KIDDERPORE AVENUE • HAMPSTEAD NW3

LISTED BUILDING APPLICATION

SKEEL LIBRARY

DESIGN & ACCESS STATEMENT

DRAWING
Steel Library
Level GF Proposed GA Plan

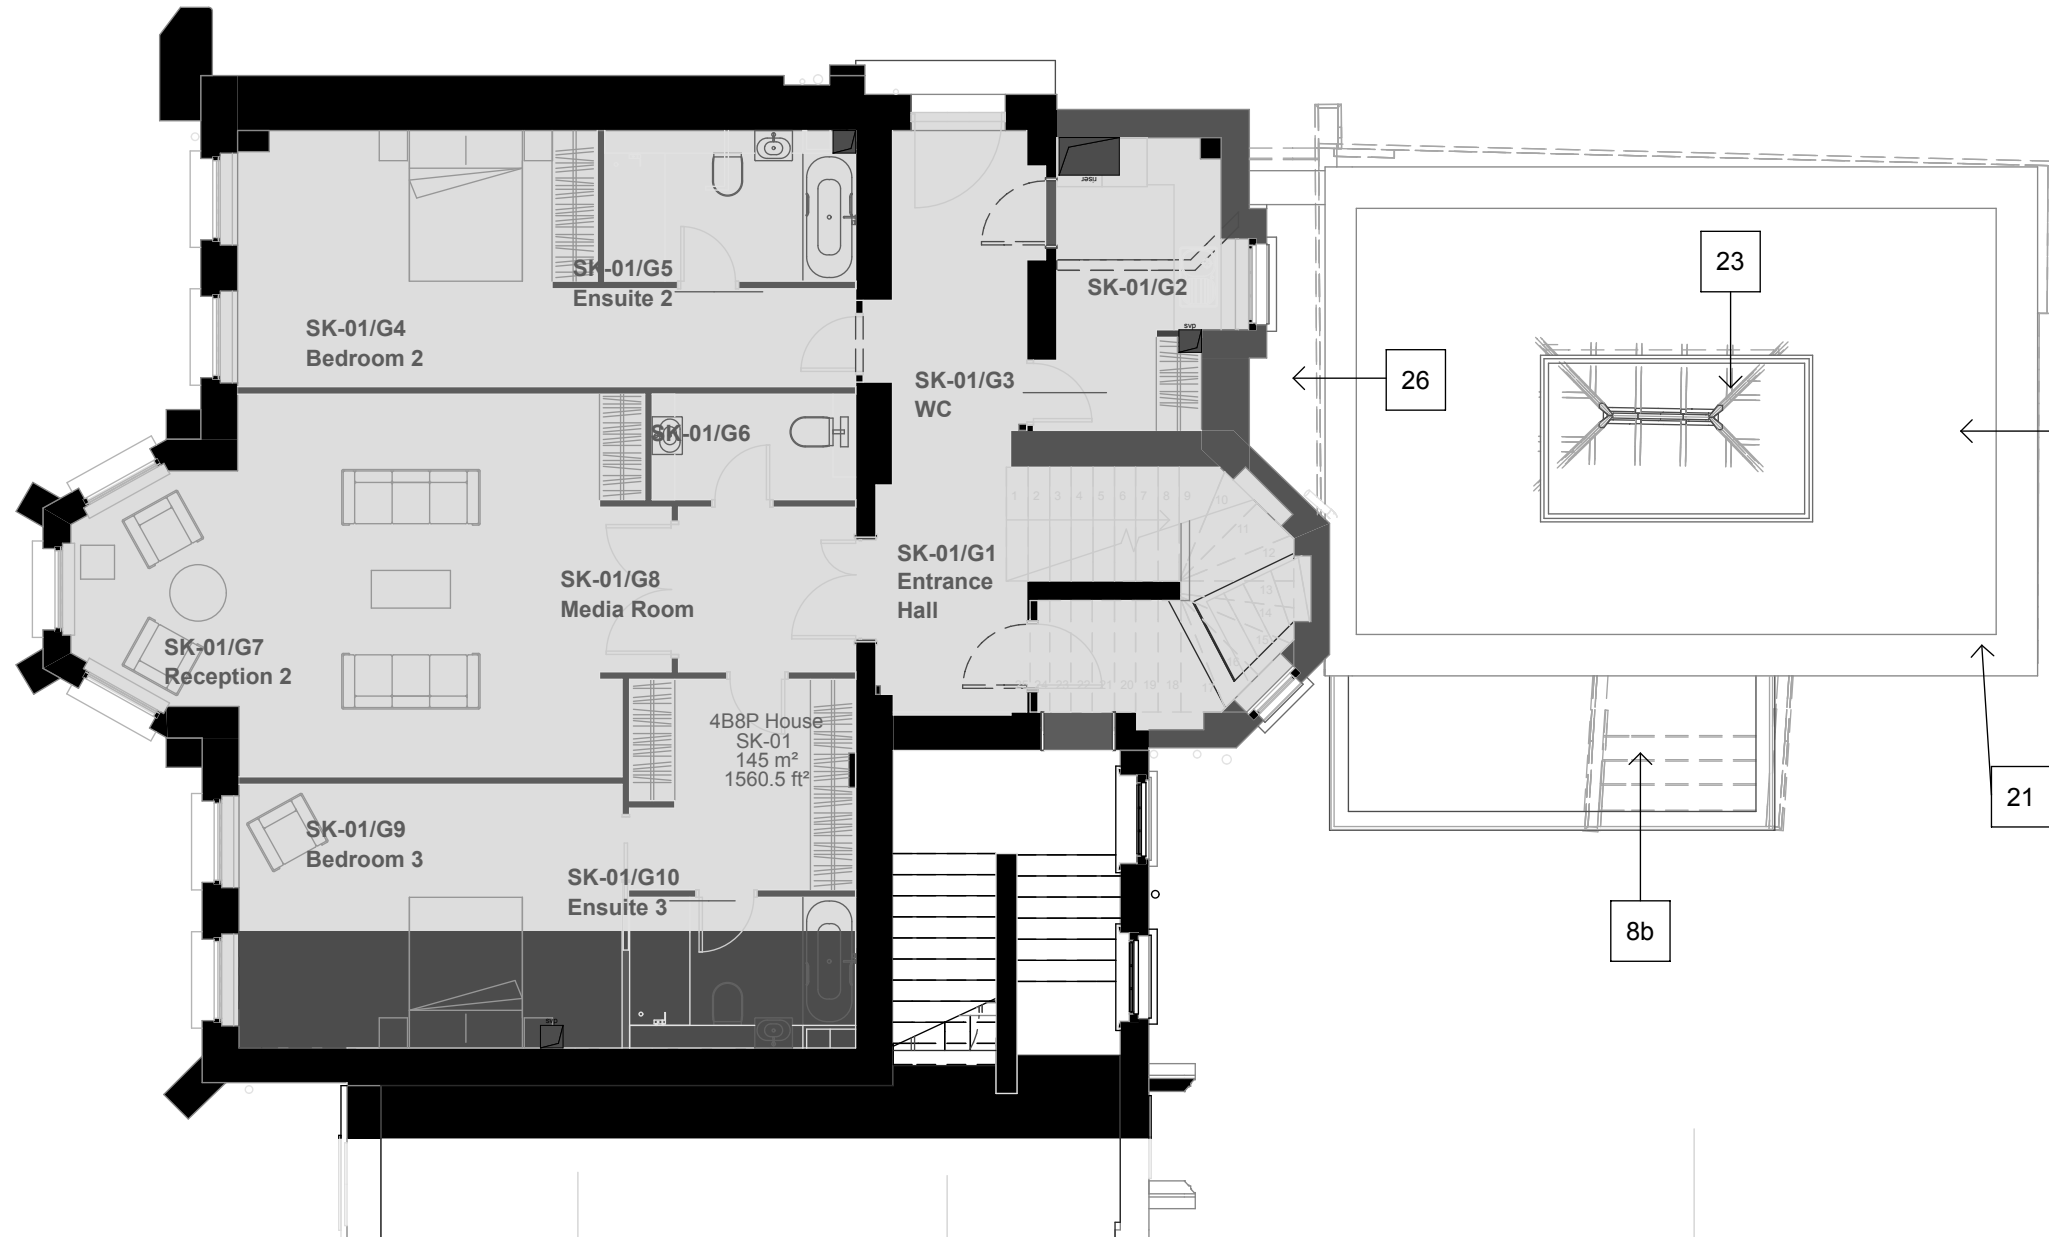
With the reworking of the lower Ground Floor as a guest bedroom suite, the opportunity has been taken to provide a master bedroom suite at the ground floor, instead of two bedrooms and a much larger media room.

The sub division of the space into three zones follows the same principle as the approved layouts.

The cloakroom area has been adapted to allow for a service riser from below, but otherwise follows the principle of the approved layouts.

Typical Acoustic treatment of existing walls

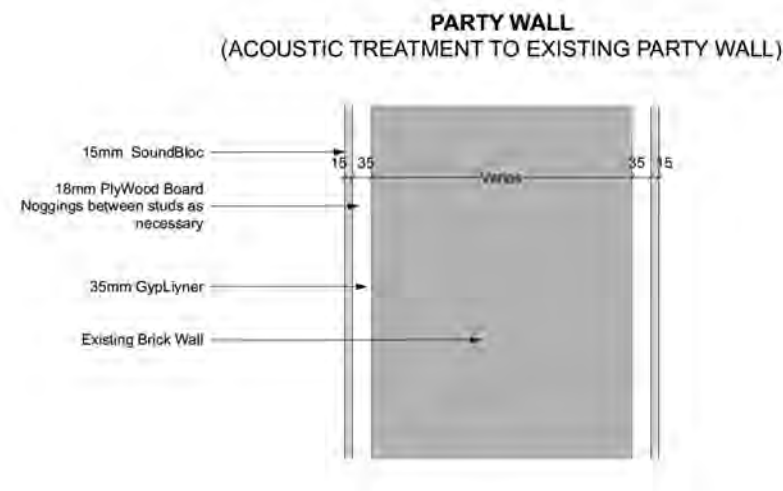
The external wall of the Living/Dining Room is to be retained without the addition of extra insulation, but the internal party walls with Bay and Dudin Brown require acoustic enhancement, which it is proposed to be provided by a Gypliner system, with insulation and new plasterboard, spaced off the existing plaster, preserved behind. This will also facilitate new services without the need to chase the existing wall face. The acoustic lining will terminate at the underside of the gallery, with a new skirting replicated from the existing, on the new plaster line.

DRAWING
Steel Library
Level 01 Proposed GA Plan

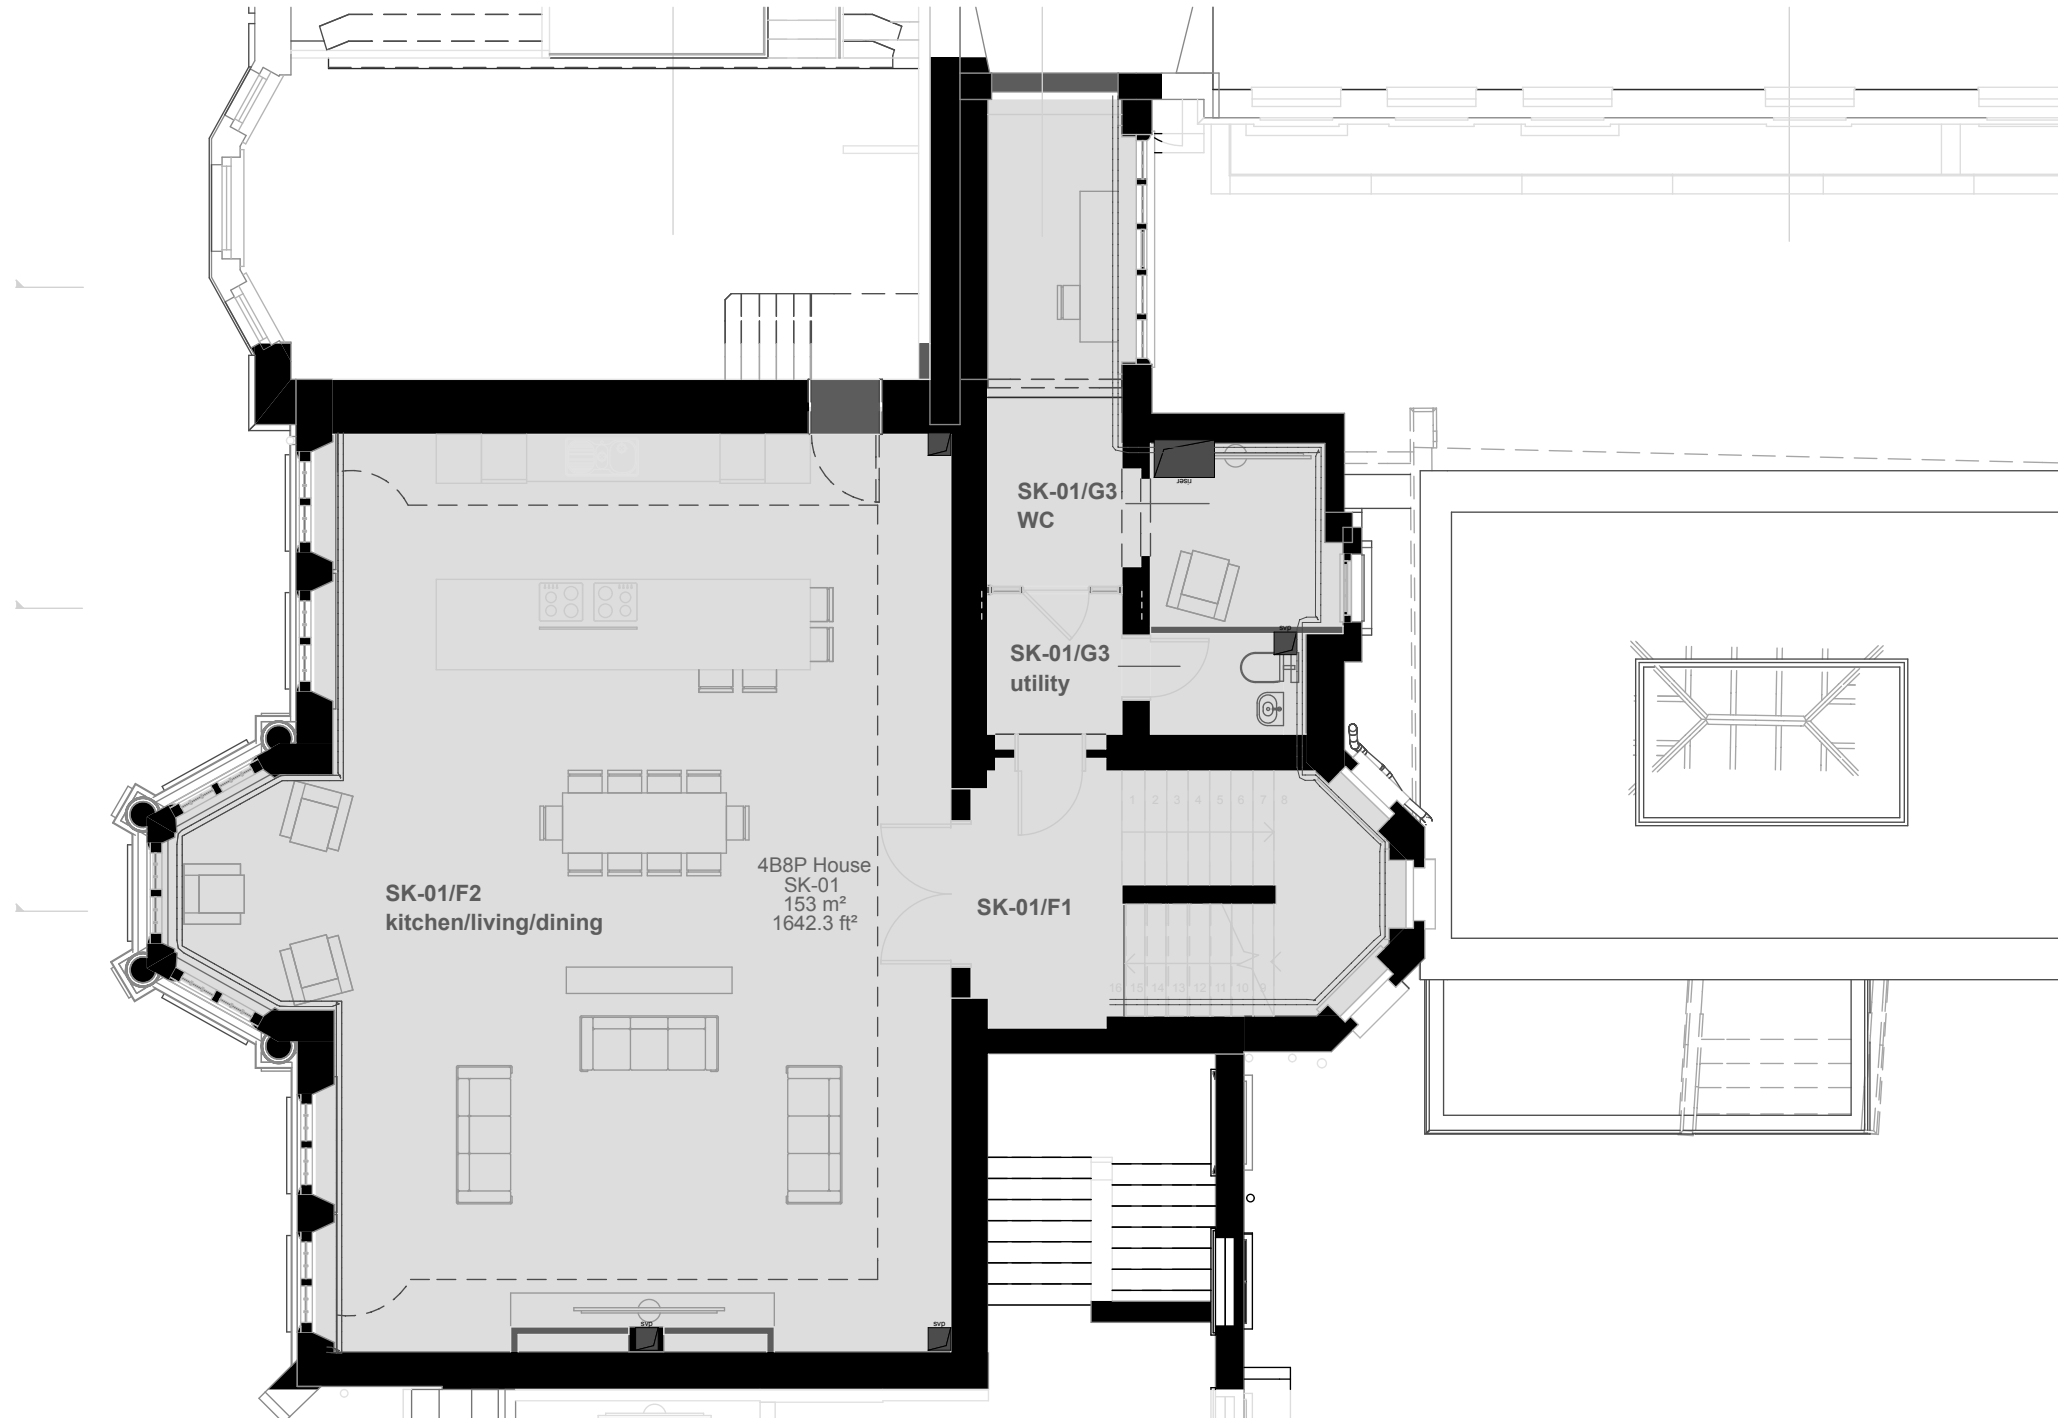
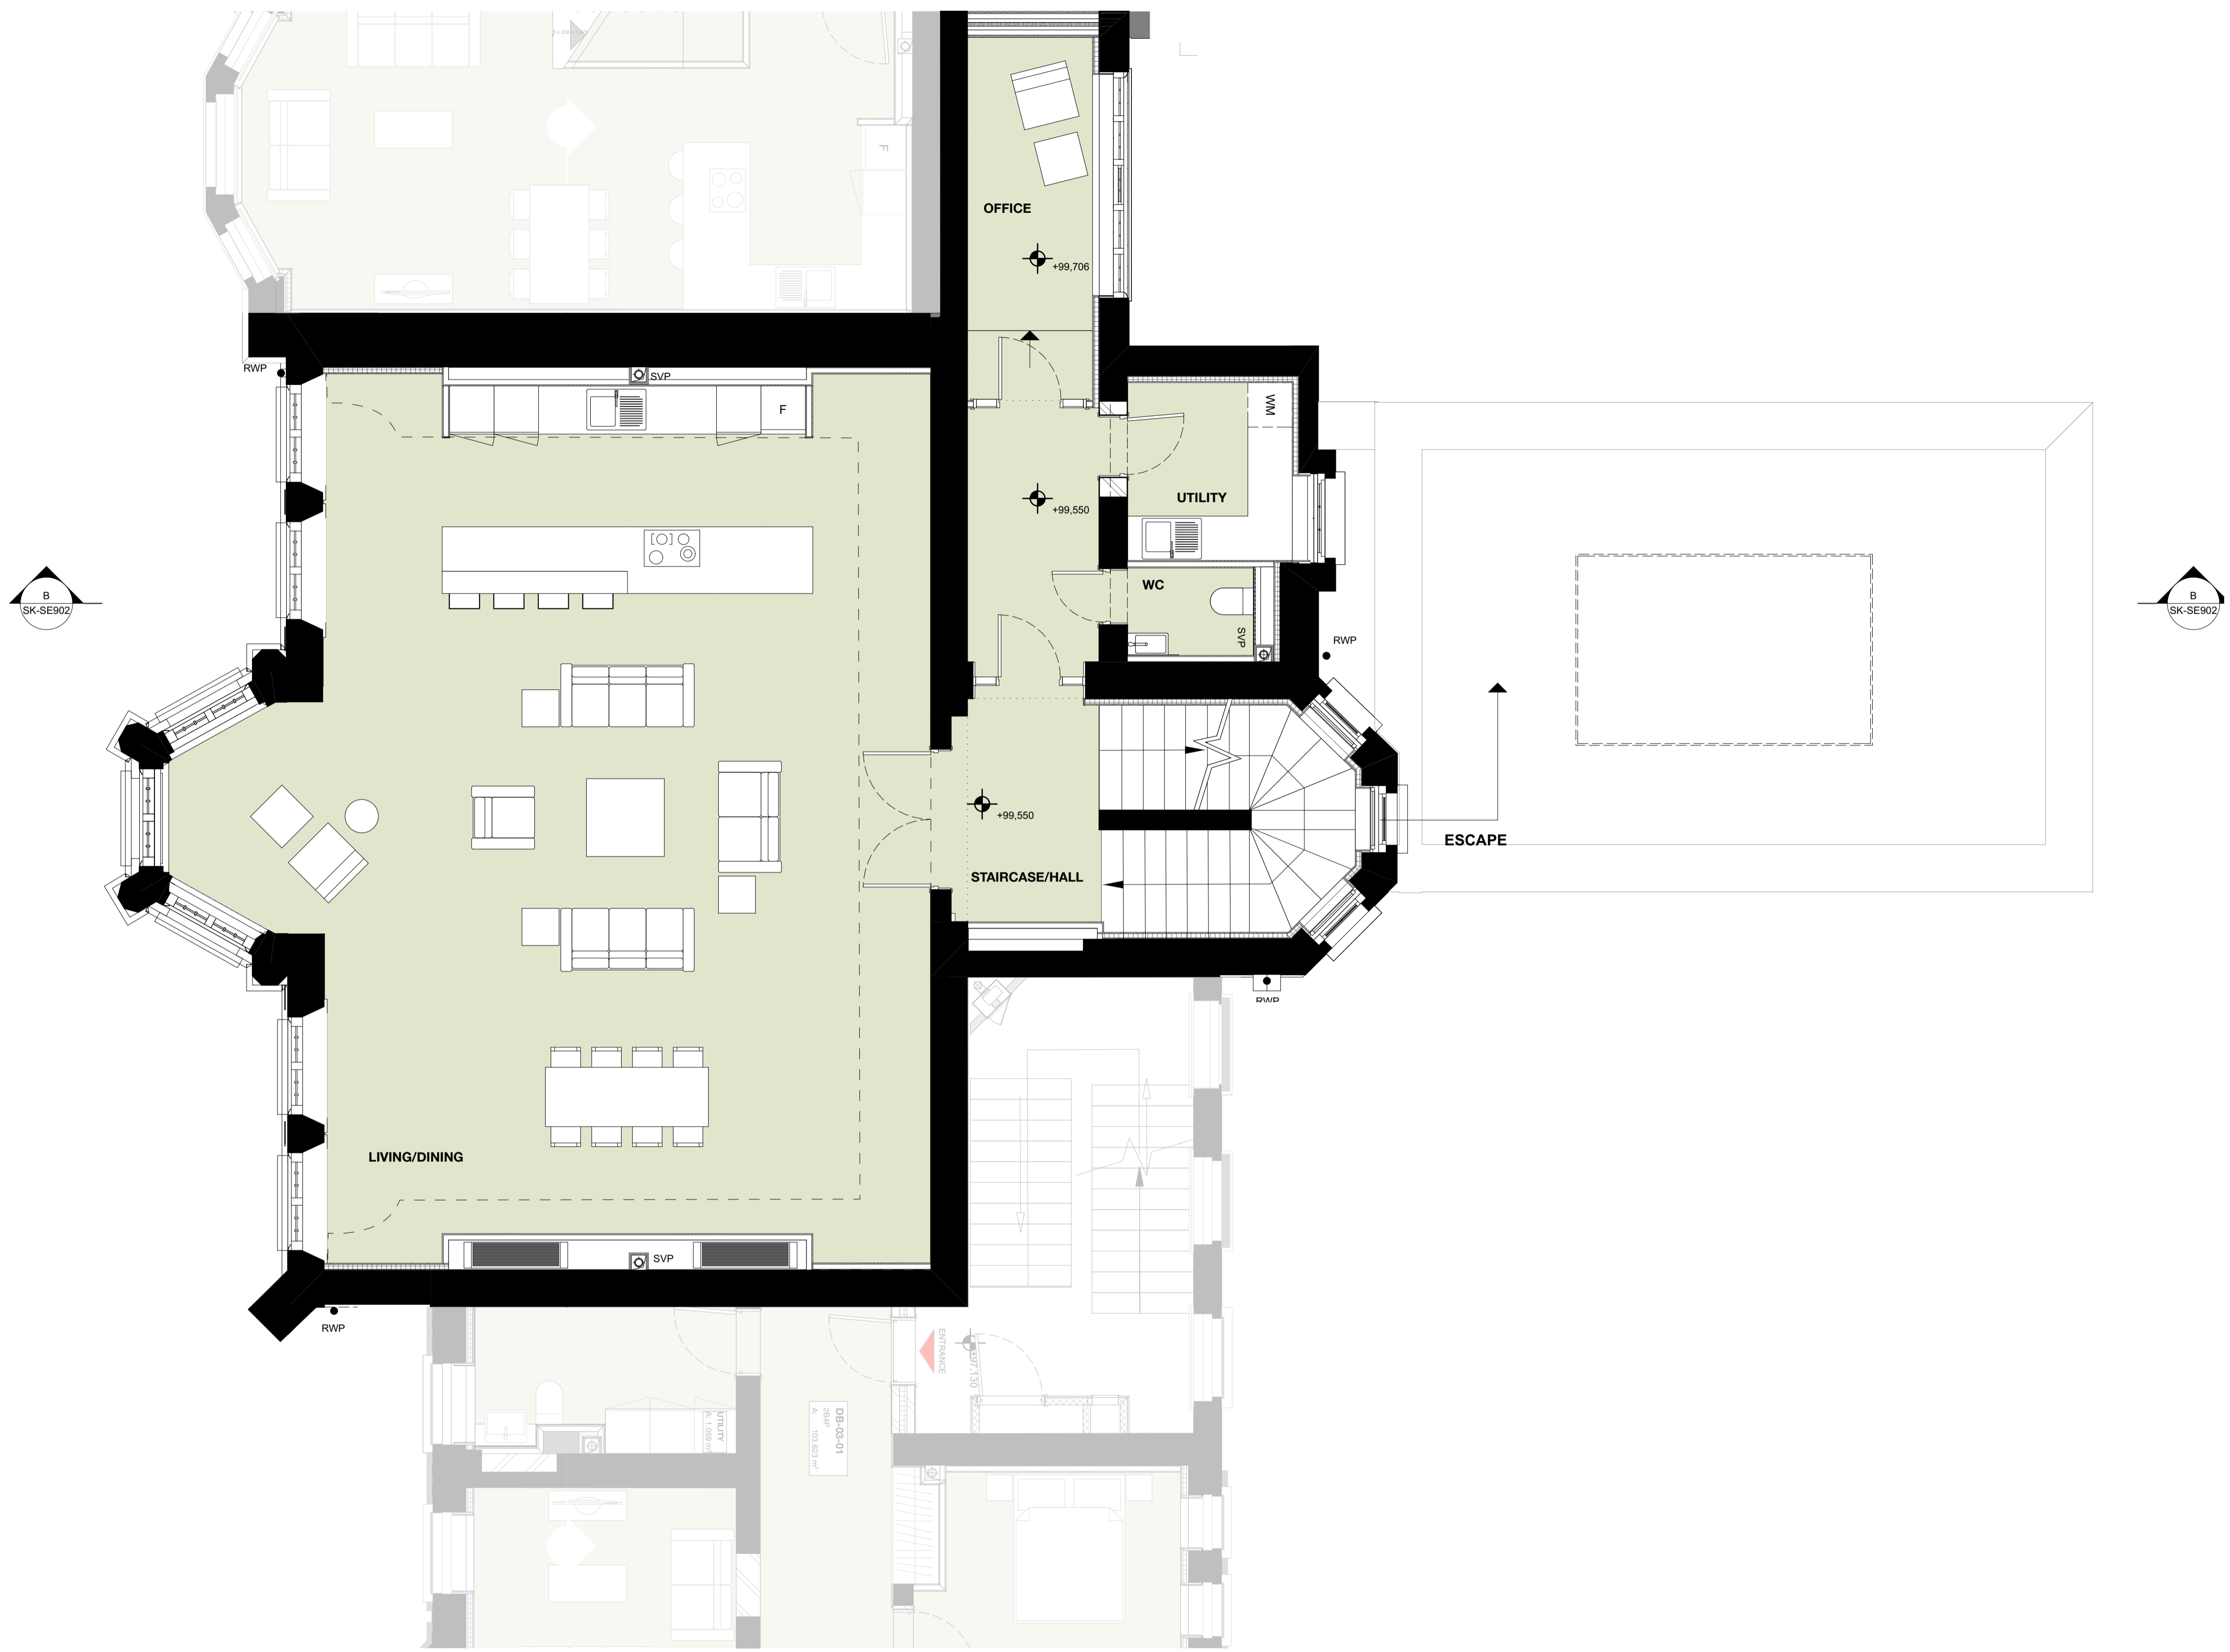
The existing boxing on the eastern wall containing former heating pipes, is expanded in order to house fan coil units as well as a soil pipe etc, to service the new residence. The false wall enclosing these services is terminated at the underside of the gallery. This wall will also house media hardware.

The width of the boxing is then reflective of the kitchen fittings on the opposite wall.

The bridge to Bay House and the Utility/WC area is reworked in more detail, but follows the same principle as the approved layouts.

It is proposed that the external walls in this rear area will be insulated to improve thermal performance, suitable for residential use. This will result in overlaying insulation, new plaster finish and new skirting, over existing walls.
